MIL-PRF-39035C  
AMENDMENT 3  
22 July 1997  
SUPERSEDING  
AMENDMENT 2  
31 January 1994

### RESISTOR, VARIABLE, NON-WIRE-WOUND (ADJUSTMENT TYPE), ESTABLISHED RELIABILITY GENERAL SPECIFICATION FOR

This amendment forms a part of MIL-PRF-39035C, dated 11 October 1991, and is approved for use by all Departments and Agencies of the Department of Defense.

FIGURE 2. Derating curve for high ambient temperatures. "

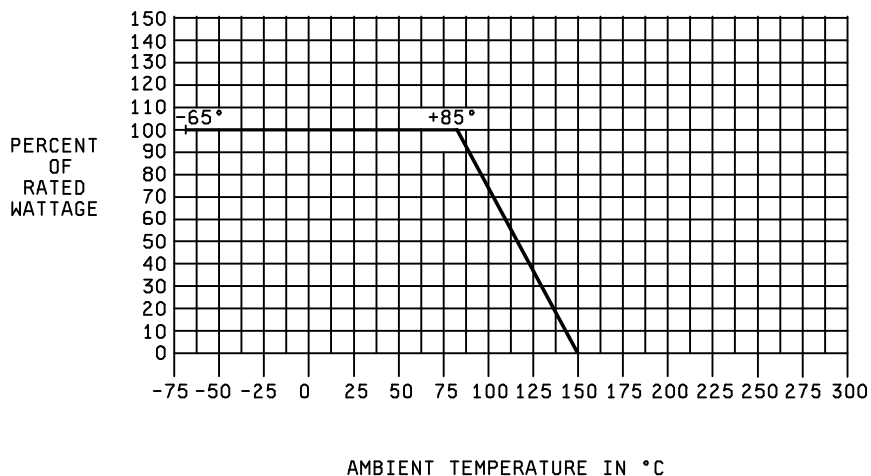
FIGURE 2, delete and substitute:
